CSB-1004-2
Country : UK
Date : 10/20/2006
APC : D54
Repair Level : 2

Title V3V3 05 CR - GSM - RAZR Earpiece Audio Distortion
Model Effected V3 & V3_05

AAC Earpiece Design Change

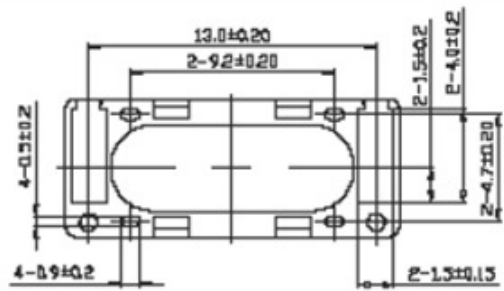
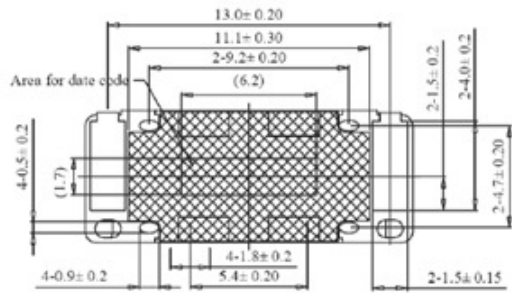
Service has detected an earpiece audio distortion issue during V3 MOL causing "Audio distortion" complaints. The root cause was determine to be FM contamination (solder ball) in the earpiece chamber being introduce during the supplier's manufacturing process (AAC).

The AAC earpiece design was change to add a mesh at the venting holes on the bottom to prevent FM contamination.

Old Part# 5089574N02

New Part# 5071324E01

P-Flex Issue Change

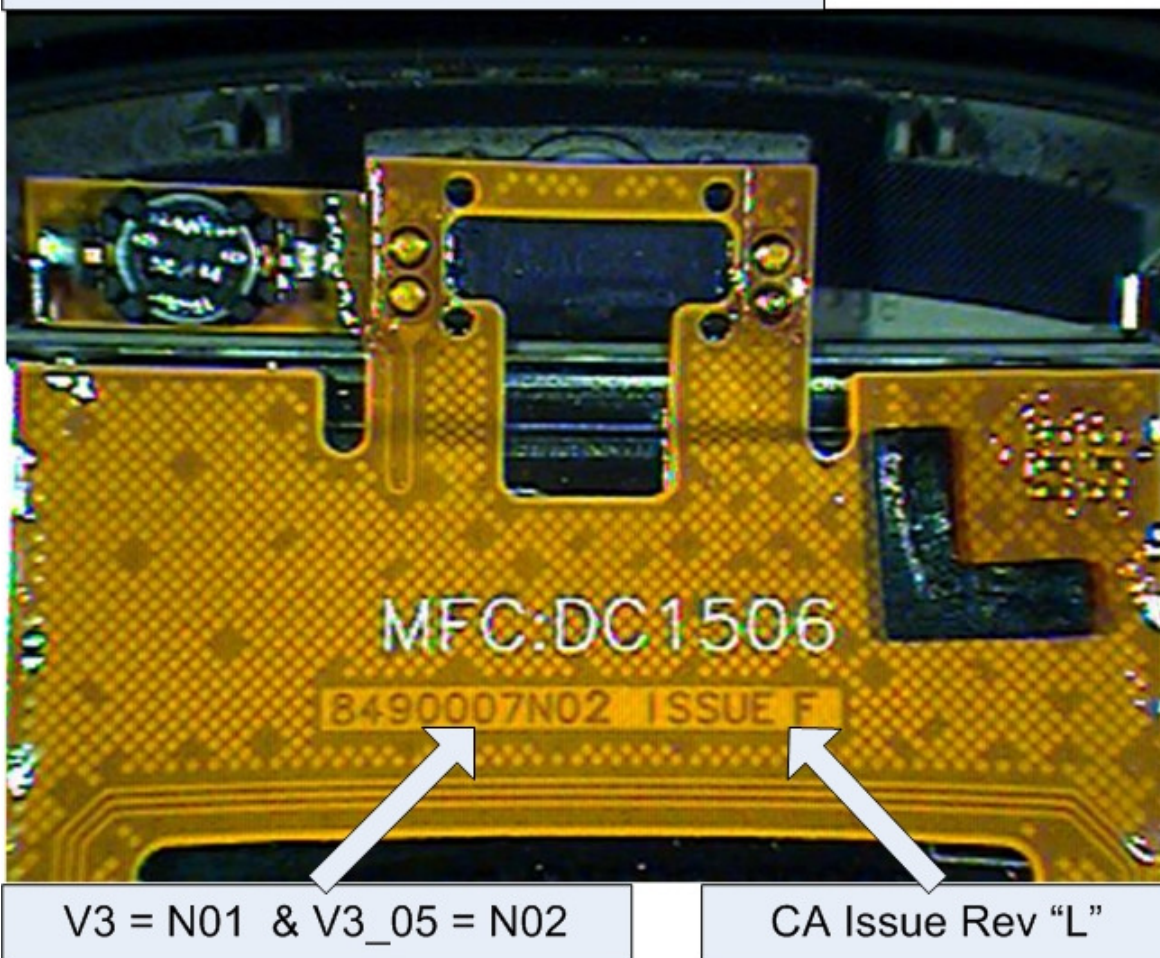
The P-Flex revision change to "L".

V3 = N01 & V3_05 = N02

CA Issue Rev "L"

When servicing any RAZR customer phones with described issue, the P-Flex must be replaced. Personality Flex Assy # 8490007N01 (V3) and 8490007N02 (V3_05) .

Service inventory new p-flex orders should be for revision "L" if available.
